**Addendum to Remedial Action Options Report (RAOR) and Pre-Design Sampling Work Plan - Connell Aluminum Properties, LLC  
Former Koppers Tar Plant and Wabash Alloys Site  
9100 S. 5<sup>th</sup> Avenue, Oak Creek, WI 53154  
BRRTS# 02-41-553761, FID#241379050  
Connell VPLE BRRTS #:06-41-560068**

March 13, 2020

**City of Oak Creek Utility Corridor Lot 1  
9170 South 5<sup>th</sup> Avenue, Oak Creek, WI 53154  
BRRTS#: 02-41-561425, FID #:341074470  
VPLE BRRTS#: 06-41-561426**

This Addendum letter addresses the WDNR's comment letter dated October 25, 2017 provided to Connell regarding *Review of Site Investigation and Remedial Action Options Reports, Former Koppers Tar Plant and Wabash Alloys Facility*. Reference is made in this letter report and/or on attached figures to the remedial actions proposed to be completed by Beazer East, Inc. including DNAPL tar removal, and barriers for PAH-contaminated soil using soil cover or potentially mobile tar capping using geomembrane.

PROJECT NO.  
 2095/6.1  
 FIGURE NO.  
 C4

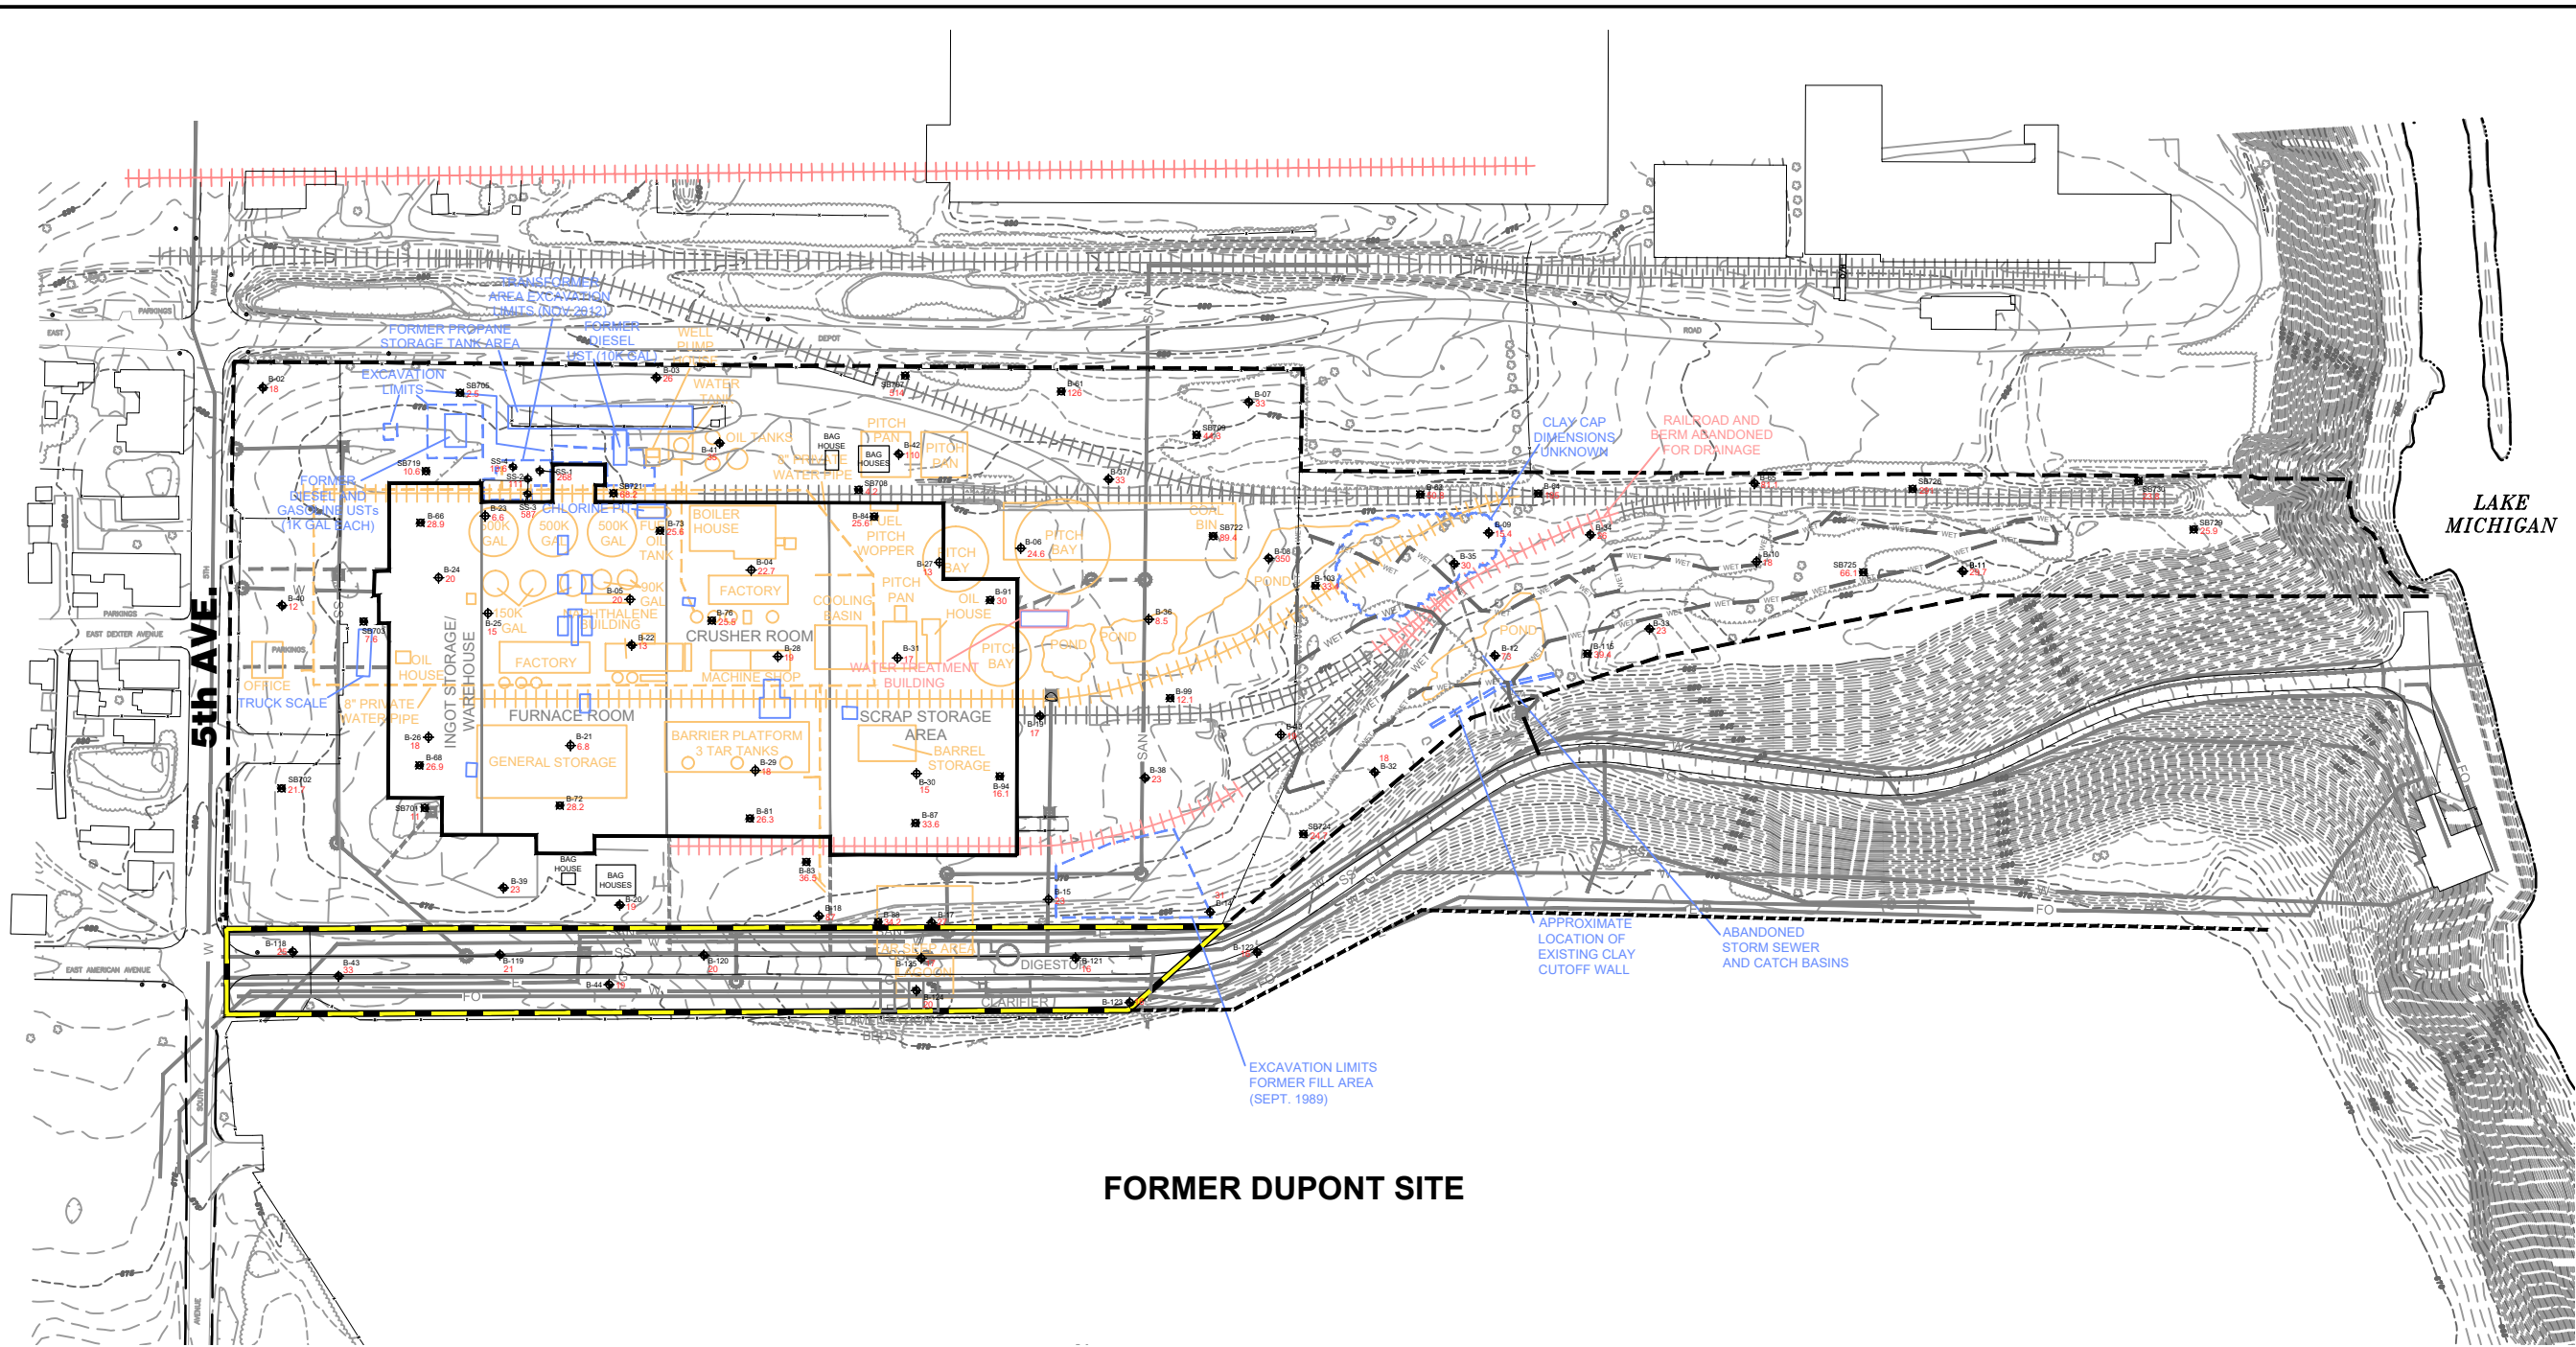
On January 27, 2014, NRT resubmitted the SI Report Figures C4 (Chromium, 0-4 ft bgs) and C8 (Silver, 0-4 ft bgs) after realizing an error on the figures that did not match the tables for chromium and silver (NRT transmittal dated January 27, 2014 is attached). Note that the data for B-08 has been corrected on these figures and are attached.

Eric – Attached are 3 hard copies of the revised figures and 3 full report CDs for the Site Investigation Report (VPLE BRRTS Activity #06-41-560068). As I mentioned over the phone, we made edits to Figures C4 and C8 and are providing updated versions. You may recycle the current Figures C4 and C8 and the CDs provided with each report. If you have any questions, please let me know.
